**HYDROGEOLOGIC REVIEW FOR THE  
ENVIRONMENTAL RESTORATION PROGRAM  
AT LOS ALAMOS NATIONAL LABORATORY**

# "HYDROGEOLOGIC REVIEW FOR THE ER PROGRAM AT LANL"

## RESPONSE TO COMMENTS

**Schematic Cross Section of the Pajarito Plateau  
(Waresback and Turbeville, 1990)**

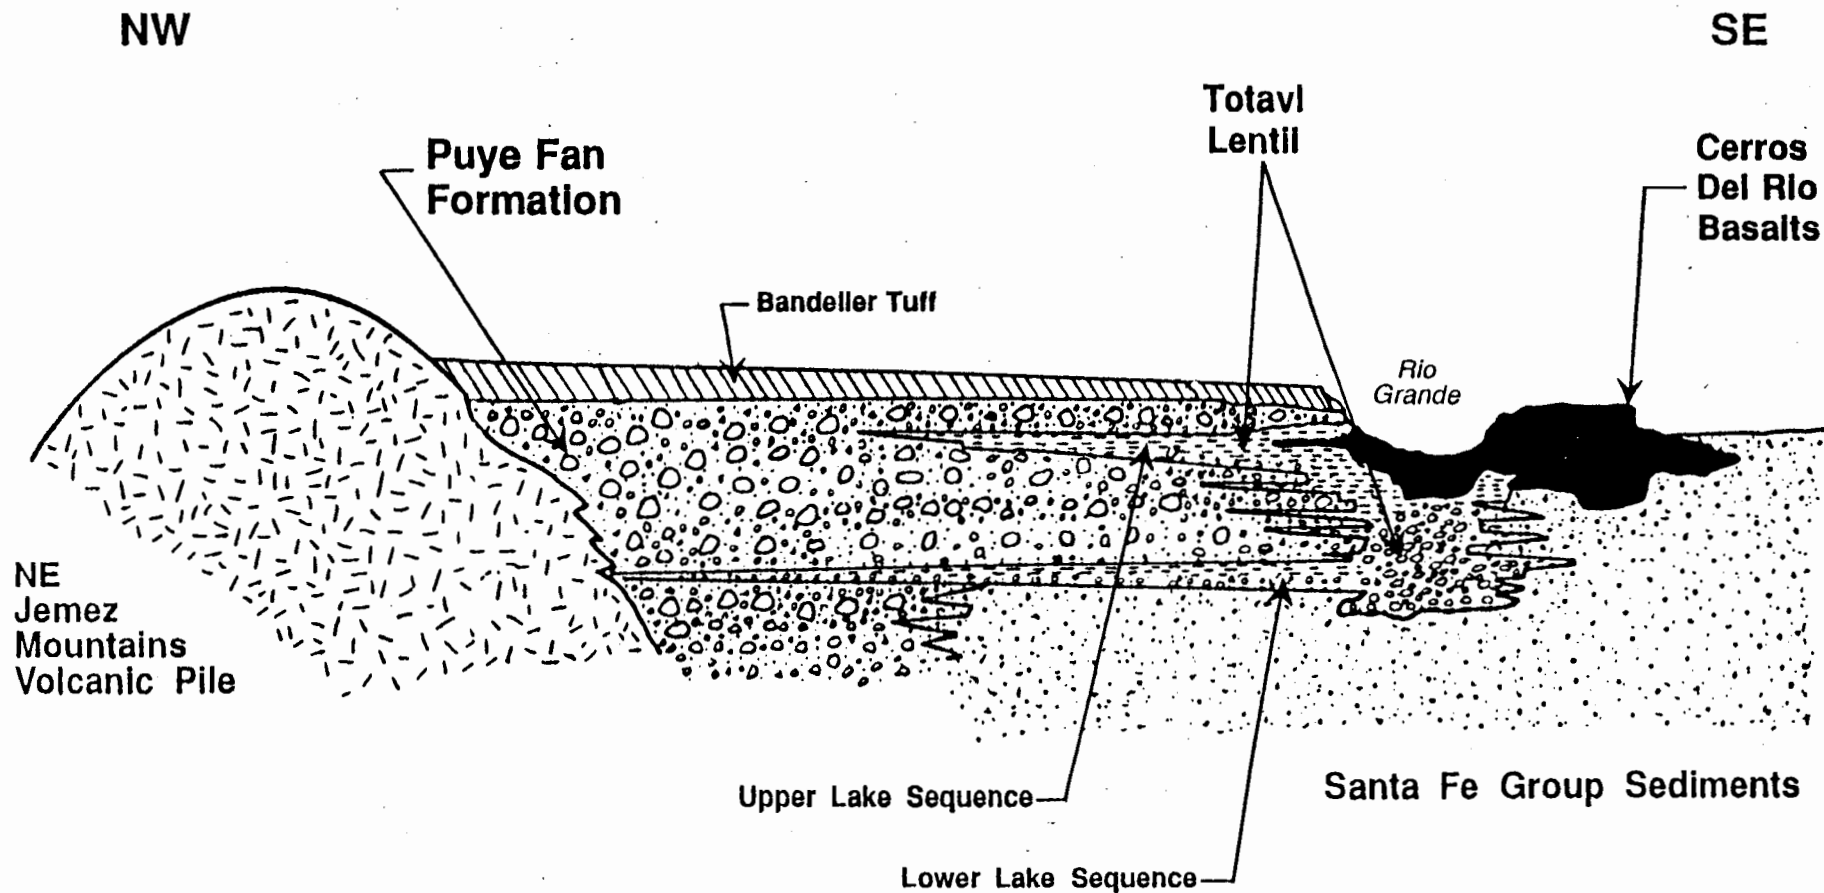
15a	11 (Fig. 1)	M	Change Totatvi Formation to Totavi Lentil	A	
15b	11 (Fig. 1)	M	Change Cerros del Rio to Basalts of the Cerros del Rio	A	
15c	11 (Fig. 1)	M	Change Bandelier Ignimbrite to Bandelier Tuff	A	
15d	11 (Fig. 1)	M	Change Puye Fm to Puye Formation	A
